PLAN COMMISSION MEETING

November 1, 2021
4:00 PM

Administrative Staff Report

Love INC of South Wood County

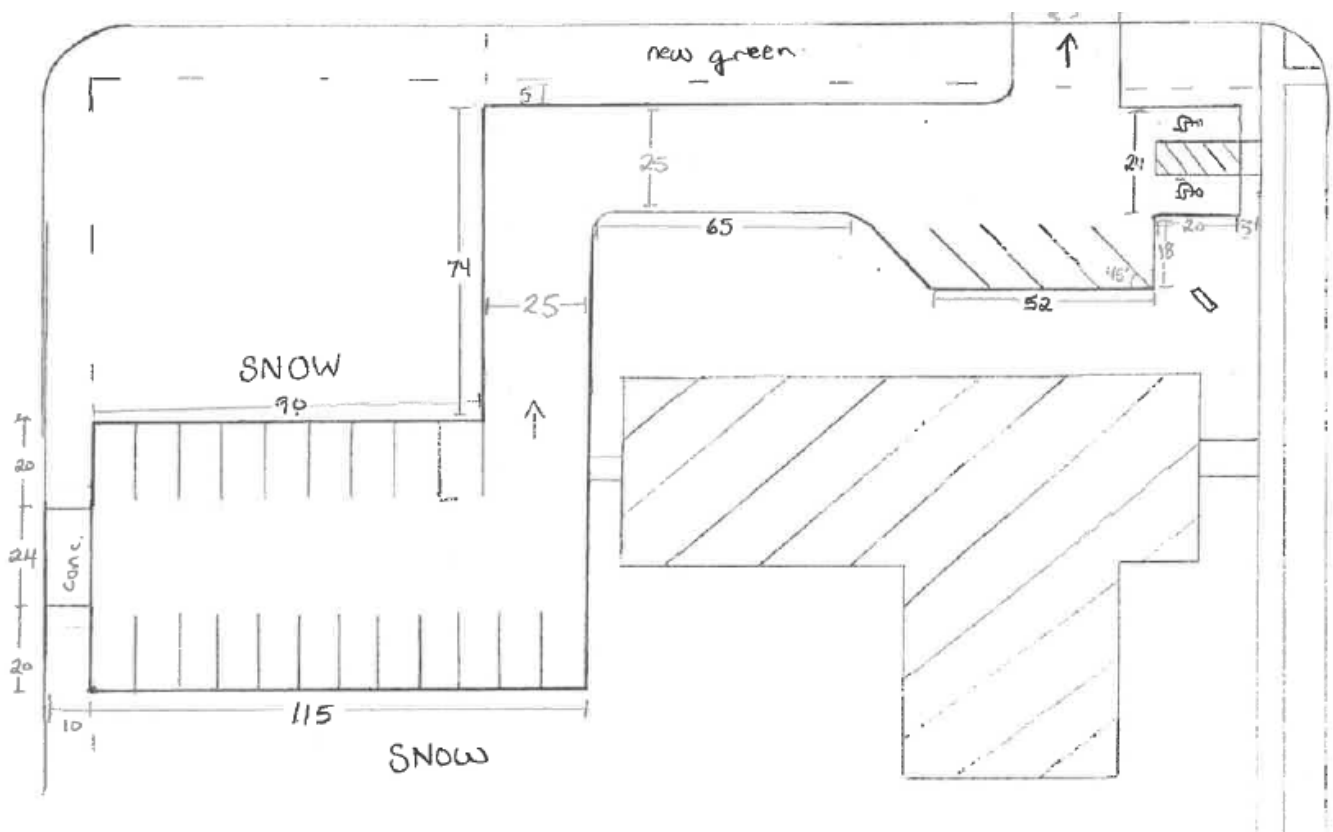
Findings: Overall, the impervious surface ratio on site will remain relatively the same, as the parking lot is not significantly being expanded. Instead, the proposed improvements shift the parking from the right-of-way onto the site and involve adding a boulevard adjacent to the street, adhering to the 5-foot set back requirement. Additionally, a proper driveway will exist on Clark Street and handicap stalls will be installed.

5) Landscaping

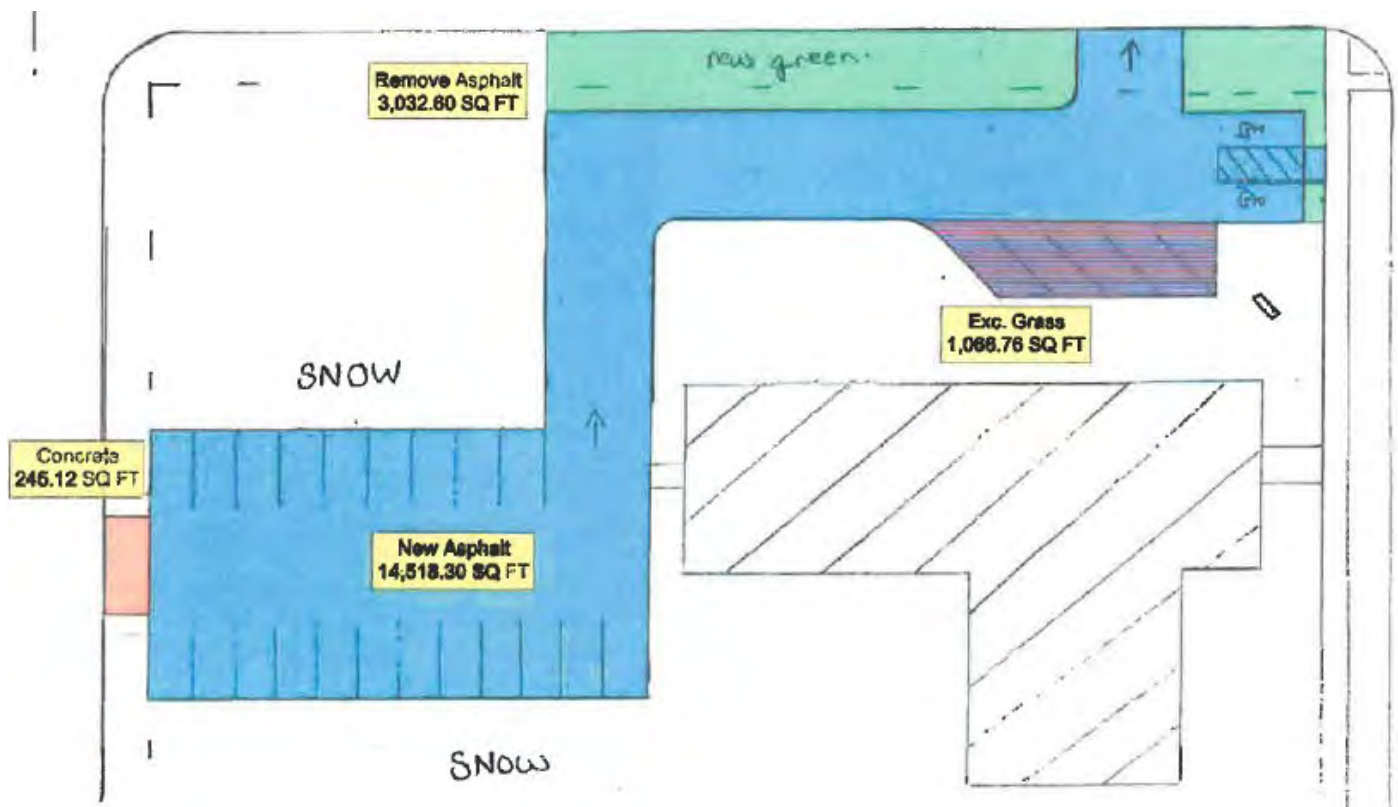
Analysis: The reconstruction in the parking area will correct the violations that exist and place the parking solely on the property. As indicated above, 25% of the total parking lot landscape requirements shall be met. The parking area is approximately 14,518 square feet, which requires $(14,518/10,000) * 100 = 146$ landscaping points. When factoring in the reconstruction deduction of 25%, a total 37 points are required. Green space is shown on the plan below, but specific plants are not shown.

Findings: Staff would recommend that a landscaping plan be submitted showing required plantings and their location. Also, a minimum of 325 square feet of landscaped area shall be located within the perimeter of the paved area for the placement of every 100 landscape points, or fraction thereof.

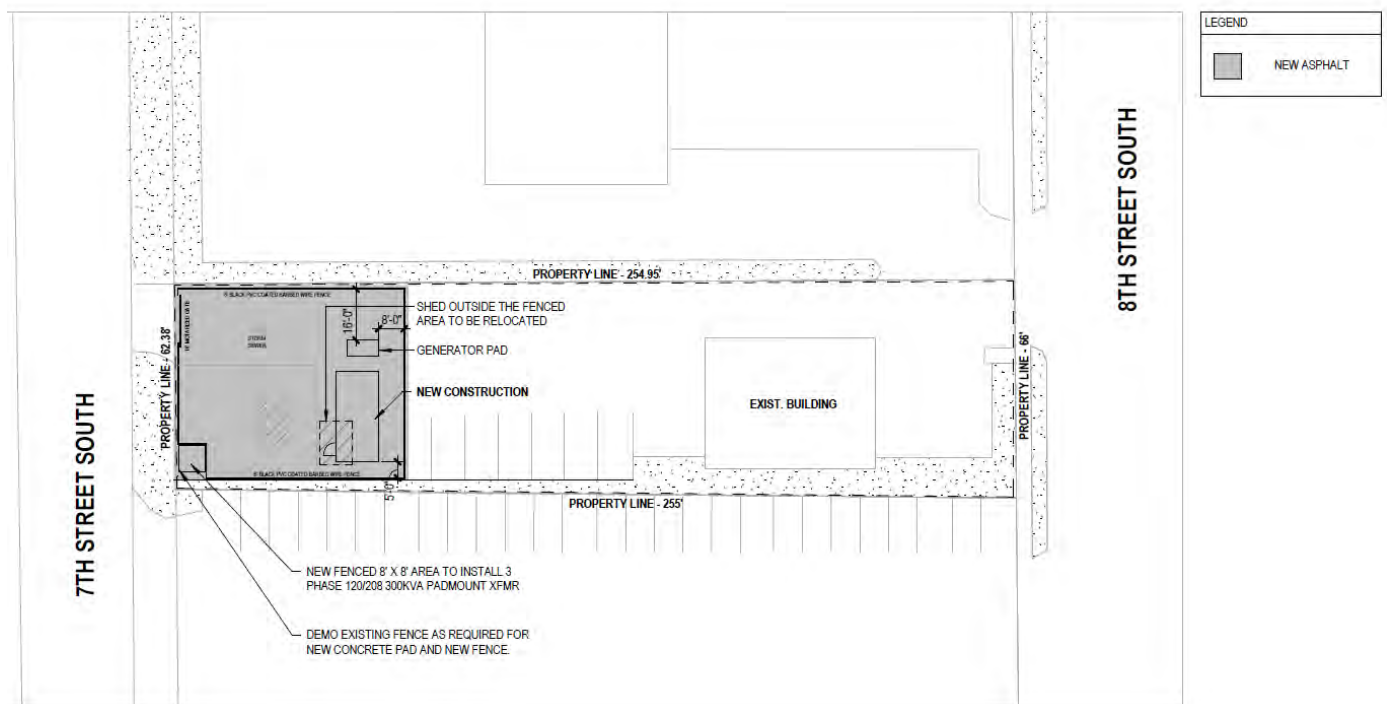
Analysis: The B-2 district requires 10,000 square feet, and the lot is over 16,368 square feet. The proposed accessory building is on an impervious area west of the existing building and meets applicable setbacks. The site is nearly completely impervious surface with a combined building coverage ratio of approximately 12.3% (70% max.). Existing impervious surface ratio is approximately 85-95% (80% max.).

Findings: The accessory structure is proposed on reconstructed asphalt surface area and therefore should not increase the ratio. Staff would recommend that impervious surface ratios shall not be increased on site.

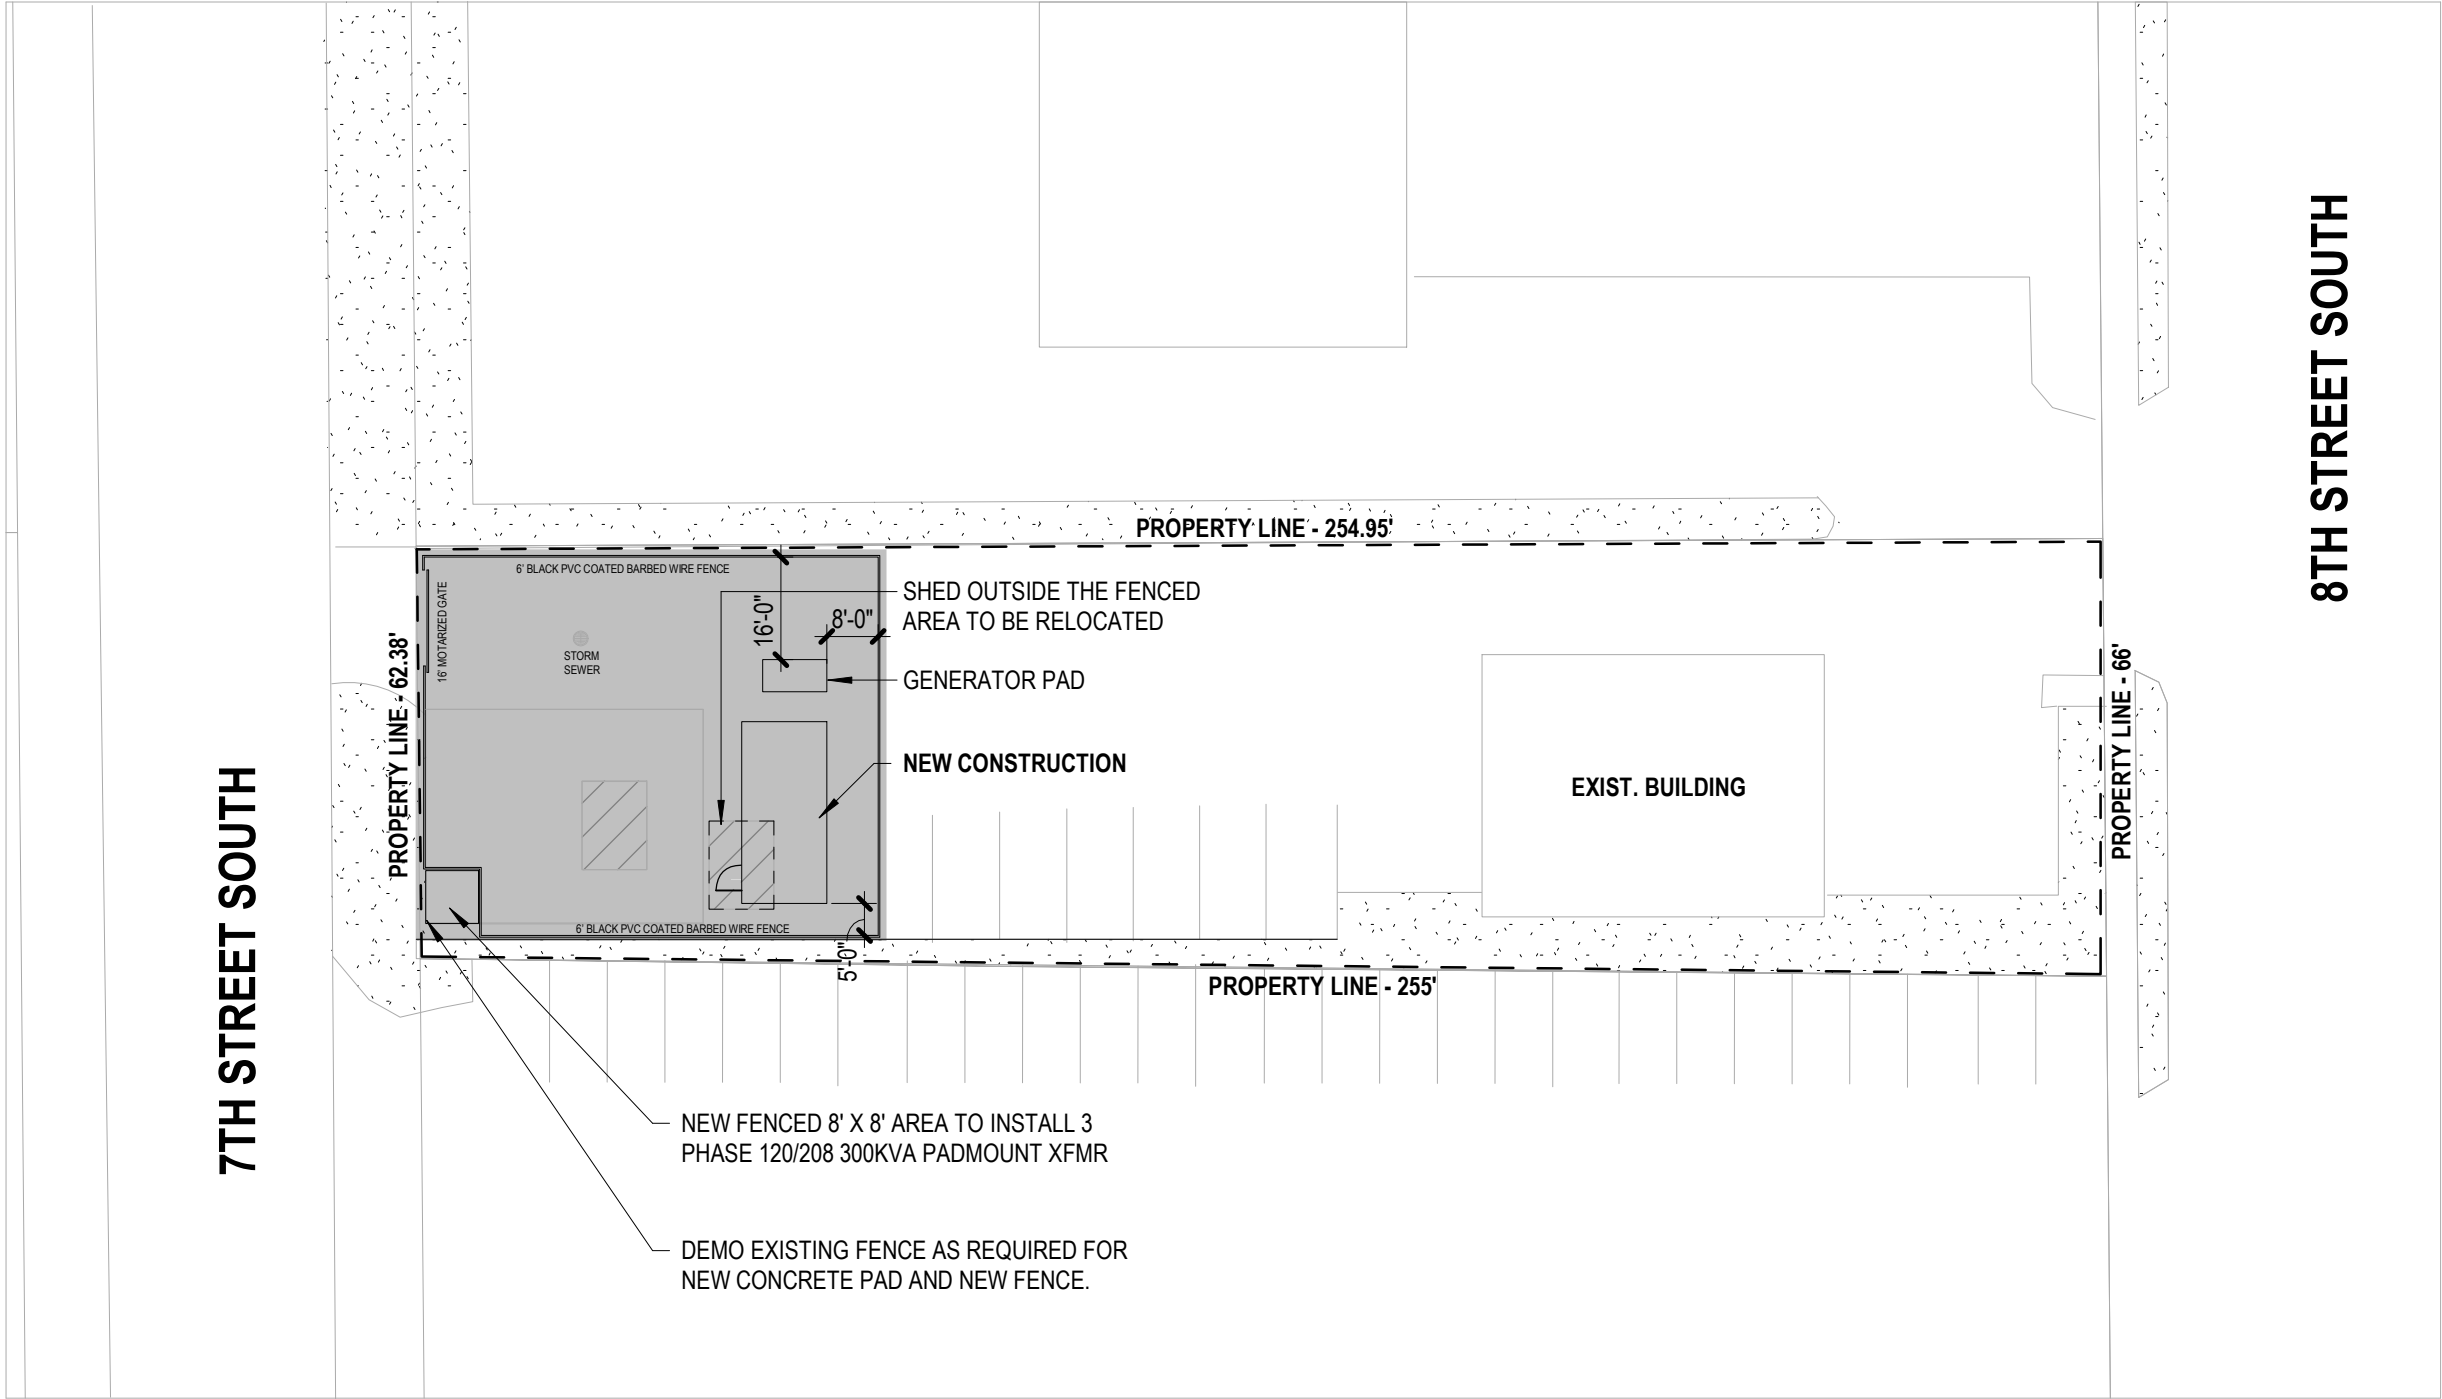
Analysis: Elevations have been submitted, showing the building façade as a precast concrete mesh aggregate. The building will resemble a textured concrete finish. A door is proposed on the west elevation and several small openings on the east elevation. As a precast building, the majority is constructed offsite and then assembled on site.

- a) **Findings:** The accessory structure should blend with the building if it matches in color. Therefore, staff would recommend the exterior materials of the building shall match the design and color of the principal building.
